THE PURPOSE OF THIS SUBMITTAL IS TO POINT OUT ISSUES THAT NEED TO BE ADDRESSED WITH NEAR TERM BUDGETS FOR PLAN DEVELOPMENT

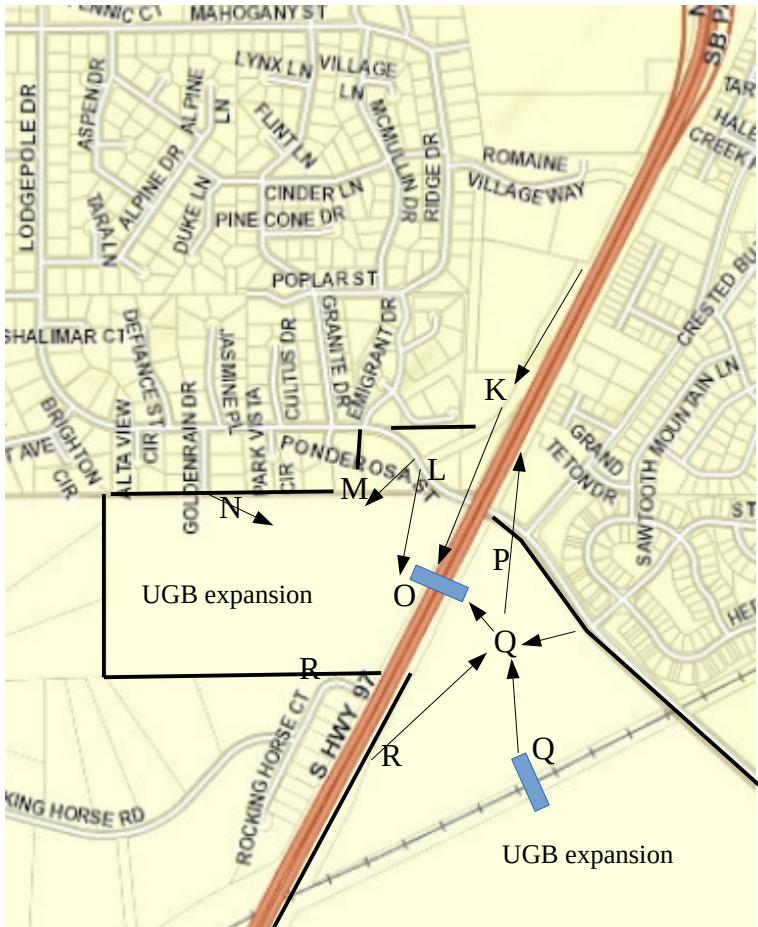
- A.** The Parkway median north of the Powers intersection needs to be partially removed and existing ODOT ROW used to provide a decel. and holding lane and free right turn from 97S to Powers W with two lanes continuing southbound.

- B.** The Parkway median south of the Powers intersection needs to be partially removed to provide a decel. and holding lane for egress from 97S to Powers E.

- C.** Remove cross-traffic access to 97S from Powers westbound and to 97N from Powers eastbound to eliminate traffic stoppage.
- D.** Consider the trade-offs between the costs of abutment, access ramp ROW, residential access blockage, four-way signals, and Third Street traffic backup of the suggested overpass design versus modest ROW purchases east of the current Parkway ROW to provide room for a free flowing interchange design.

- E.** The notion of a Murphy frontage road predates the now existing congestion from on-street parking on both Blakely and Badger and questionable intersection with Murphy.

- F.** Southbound egress from 97S to Murphy via the above frontage road or egress near Pinebrook meets Murphy at the west end of the bridge where “as-built” appears to provide inadequate ROW for the roundabout once planned, making the egress questionable, and support of **G** becomes necessary.

- G.** This planned egress from 97S, **F** is unavailable, is desperately needed to reduced use of Powers and Reed Market for access to both Brosterhouse and Murphy and cannot wait for development of Murphy Crossing plan to provide frontage road **I**.

- H.** The northbound access planned here appears to barely meet accel. lane length, but 97N access is desperately needed for safe access and reduced use of Powers and Reed Market 97N access. Depending on its impact on the existing Powers interchange, a possibly lower cost access point could be converting the 97N RIRO access at Badger to a right out only access with a proper acceleration lane.

- I.** The Hwy 97S egress provided at **D** could also serve as southbound Hwy 97 traffic using the proposed eastbound crossing at China Hat (see **K**) since any 97S egress closer to China Hat is complicated by the Third Street access to 97S which extends all the way to Romiane Village.

- J.** Projects planned for the existing China Hat ROW could wait for Hwy 97 over-crossing decisions regarding alignment since this is also dangerous intersection that may be moved.

**K.** Southbound egress to the China Hat over-crossing could occur north of here, but it very close to the terminus of the Third St. on-ramp accel. lane. There would be an intersection with the frontage road here where a full length Hwy 97 southbound on-ramp would start to reach a terminus prior to the China Hat over-crossing bridge.

**L.** The current Ponderosa St. ROW alignment and CTAC drawings will not provide the needed rise-to-run to reach a required bridge height. To gain the necessary length Ponderosa St. turns south as it begins its rise and here it could four-way intersect, with signal, the frontage road from **K**, with through traffic to and from Baker via Buck Canyon at **I**, and traffic to and from China Hat **K**.

**M.** Improvement of the Baker/Knott Interchange, discussed later, will be so costly that connecting to Baker via Rocking Horse and Buck Canyon will constitute an ROI here that justifies expenditures for a China Hat crossing.

**N.** This alternative to extending Ponderosa may be a more cost effective way the west to the China Hat over-crossing. From **J** the ramp to

the bridge would follow the most cost effective line, given that the approximate crossing point shown is dictated by topography and connectivity issues on the east side of Hwy 97. If this approach is taken, the intersection of roads described as a four way stop could use a roundabout and Ponderosa St. could turn north at **L** to become the westward extension of the frontage road. The southbound access to Hwy. 97 would still be required at **K** because such access will not fit anywhere else in the proximate area.

**O.** The crossing point for the proposed bridge is dictated by the available starting point for the northbound egress from Hwy 97 which must start after the R/R bridge, the terminus of the northbound access to Hwy 97 which must end at existing residential development, the need to access Parrell Rd./Stonigate subdivision, and the R/R over-crossing east of Hwy 97 which becomes more cost effective approximately 800 feet south of the existing China Hat crossing.

**P.** The access to northbound Hwy 97 could either pass under the highway over-crossing bridge, thus requiring a longer or second bridge span, or come out of the westbound lane of the roundabout at **Q**.

**Q.** Though substantially dictated by the roads that compose it, the location of this intersection is also dictated by the topography of the area because it impacts ramp cost necessary to bridge the railroad. The 2009 Central Oregon Rail Crossing study suggests a best crossing point is approximately 800 feet south of the existing.

**R.** The current 97N access to Baker Rd. could now move to the China Hat crossing and access Baker Rd. via Rockining Hourse. Upon the completion of the Ponderosa/China Hat project, the access it provides to Baker Rd. will require improvement of Rocking Horse and Buck Canyon to arterial standards.

**S.** There appear to be access points and ROW to both sides of Arnold Canal, but they don't align from one side to the other. Access will need to be resolved since this is a critical element of the Ponderosa/China Hat project in terms of ROI realized.

**T.** The 2009 Central Oregon Rail Crossing study points out the disaster that is this interchange. This study stated that to bridge the railroad the existing structure would need to be destroyed and a new complex, with the same crossing traffic, built at 25 feet above grade. The current Parkway Plan suggestions include, without above grade rail crossing, signaled intersections for this cross traffic or a traffic circle. But a traffic circle of adequate size for the volume of truck traffic here, similar to Murphy/Third St., will not fit in the available ROW. To cross the R/R above grade **and** address the cross traffic the existing interchange could be kept, but four additional bridge spans and a traffic circle east of Hwy. 97 would be required to allow a free flowing interchange. This is an unimaginable cost that the Ponderosa/China Hat project could preclude by eliminating Baker Rd. access here.

If this R/R crossing were abandoned, the DRW area would need a “second way out” in case of wildfire. There are two such likely locations within a mile south of Baker Rd. that would represent a more simple and cost effective answer.

**U.** A primary access point to this UGB expansion area with alignment appropriate for the China Hat crossing is best placed here since this could be future access to the privately held 1,000+ acres south of Knott Rd and to NFS Rd. 100 which could be the southern terminus of a future east-side bypass.
